Correspondence Between Staff and Applicant

**PRELIMINARY PLAT
ONE SCOTTSDALE
SCOTTSDALE, ARIZONA**

ONE SCOTTSDALE- Scottsdale, Arizona

RE: 61-DR-2015#2 and 7-PP-2007#3
One Scottsdale Planning Unit III Master Site Plan and Phase I
4P864 (Resubmittal Key Code)

DRAWING NAME:
2015-154 PLAT
JOB NO. 2015-154
DRAWN: JLD
CHECKED: JAS
DATE: 07/22/2019
SCALE: 1" = 80'
SHEET: 2 OF 2

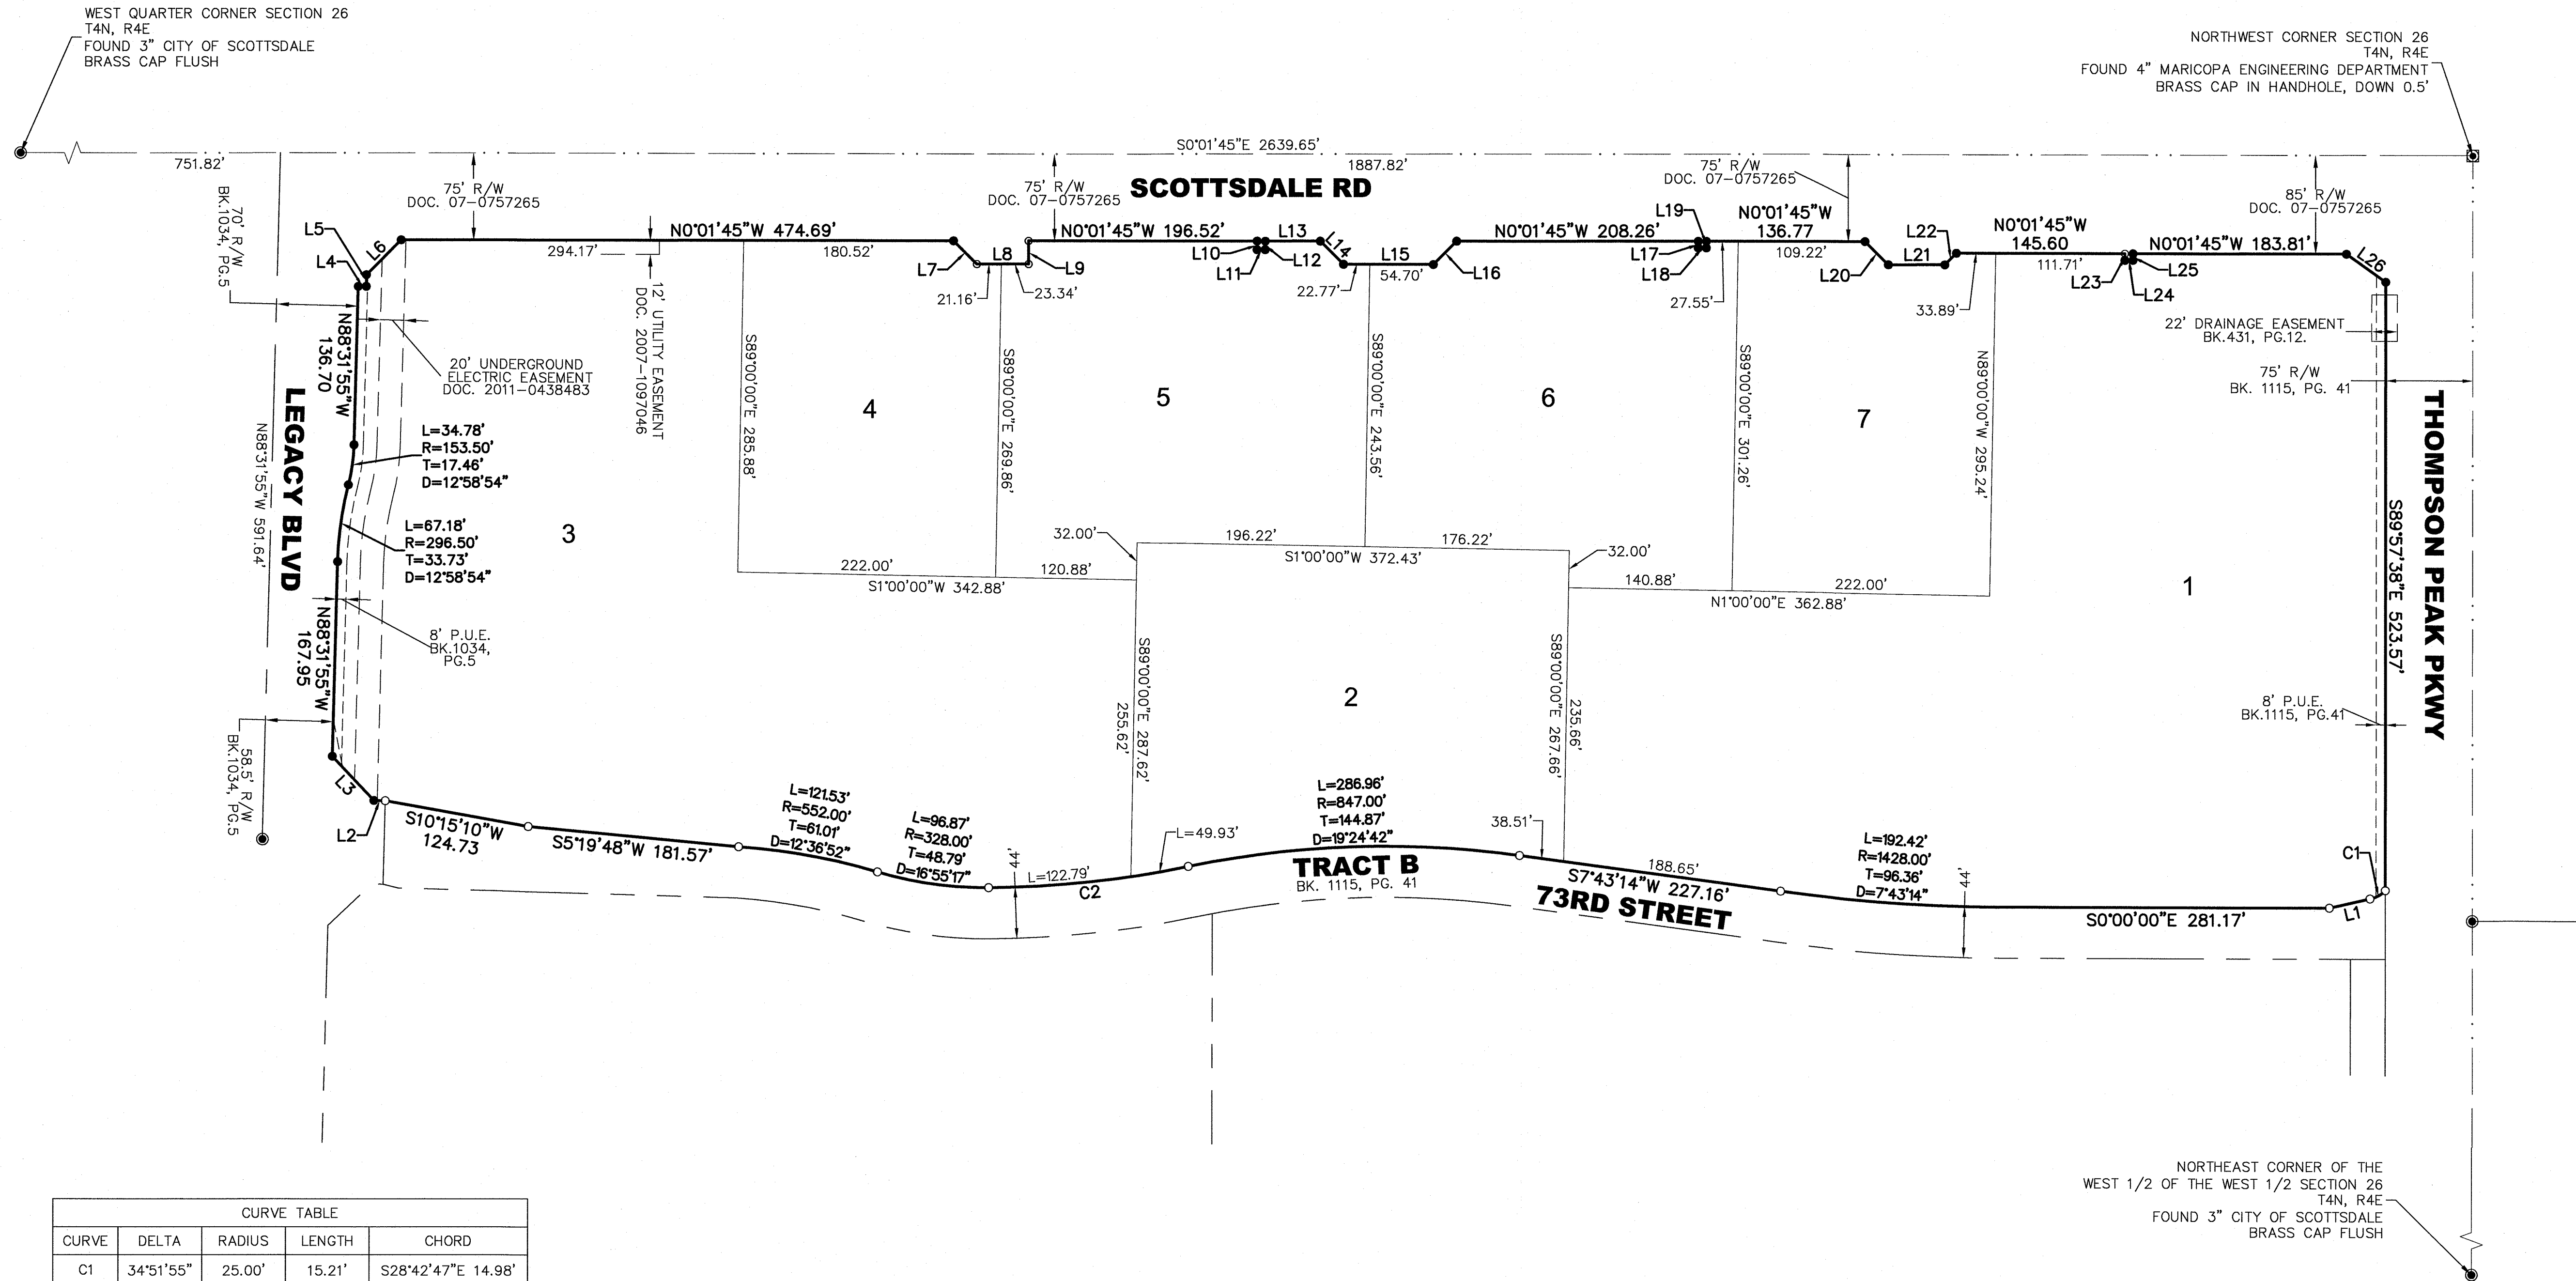
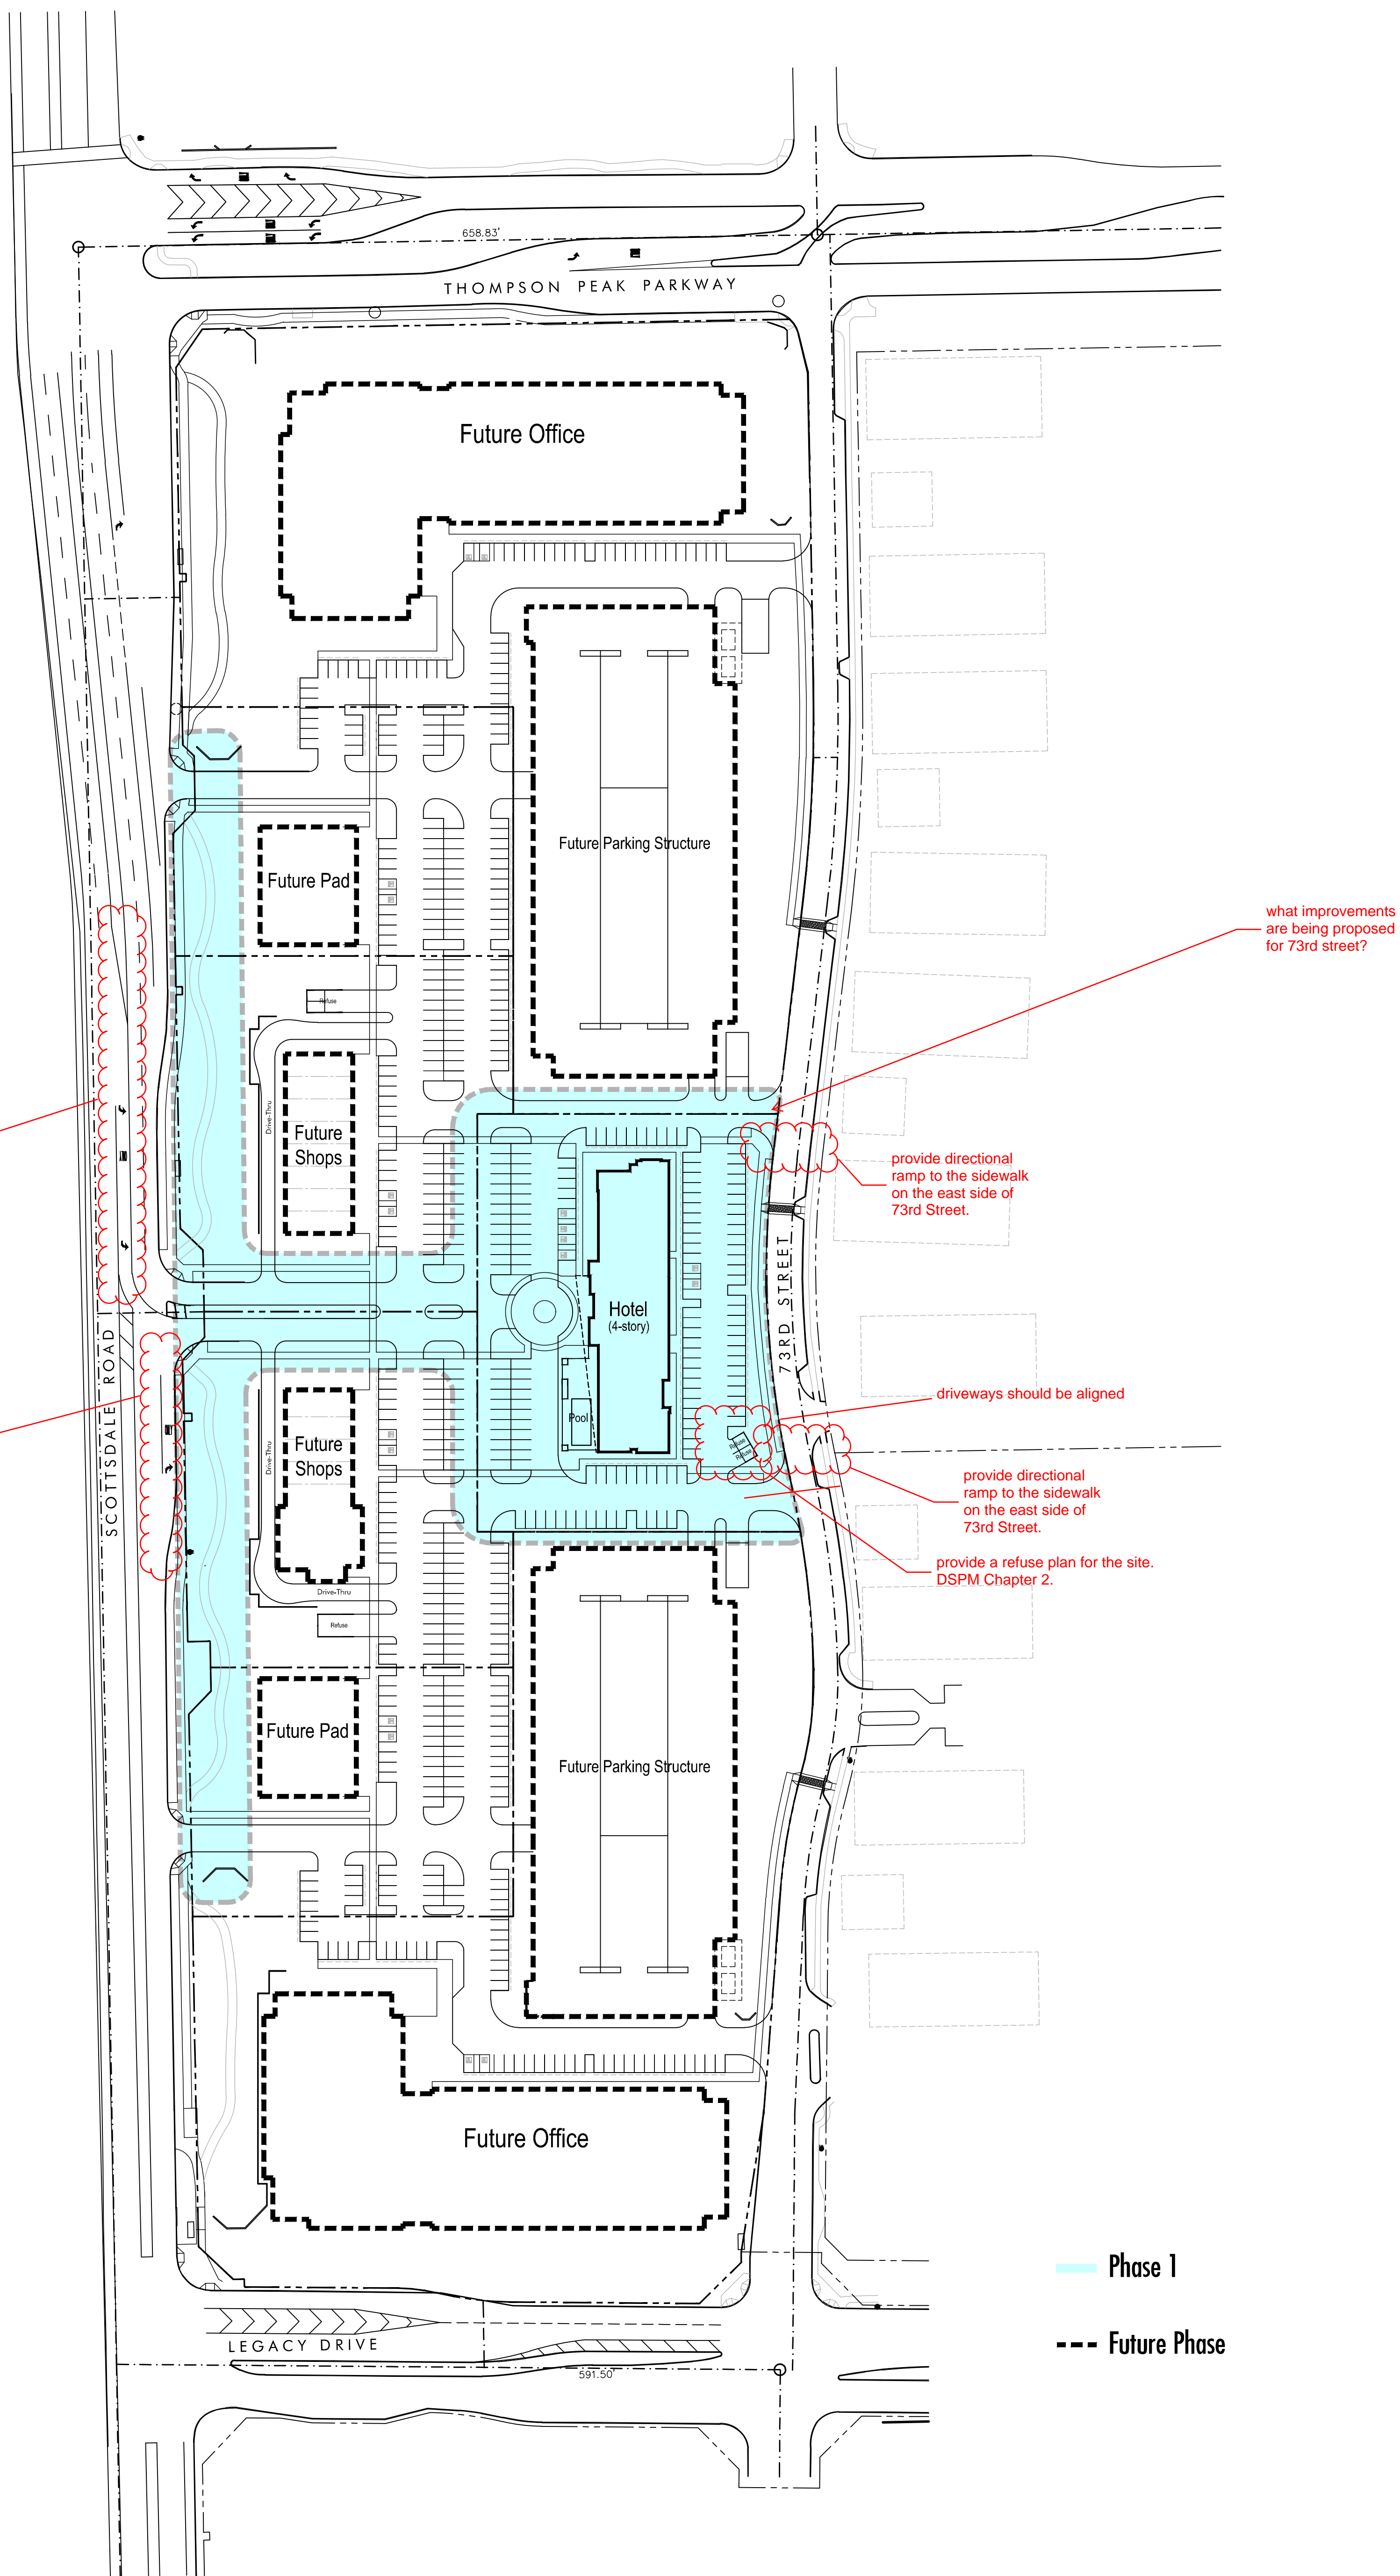
SHOW ON THE PRELIMINARY PLAT SITE PLAN THE REFUSE LOCATION. HOW WILL REFUSE BE MANAGED FOR THE SITE, AND WITH EACH PHASE OF THE DEVELOPMENT.

SHOW ON THE SITE PLAN ALL PHASING OF THE DEVELOPMENT. THE PROJECT WILL BE PERMITTED AND CONSTRUCTED BASED UPON THE PHASING AS ESTABLISHED ON THE PRELIMINARY PLAT. SHOW THE WATER AND SEWER MAINS EXISTING, ADJACENT TO THE SITE. SHOW TALL THE PROPOSED WATER AND SEWER MAIN EXTENSION TO SERVE DEVELOPMENT.

SHOW SECTIONS FOR ALL ROADWAYS AND STREET TRACTS, WHAT IS EXISTING AND WHAT IS BEING PROPOSED.
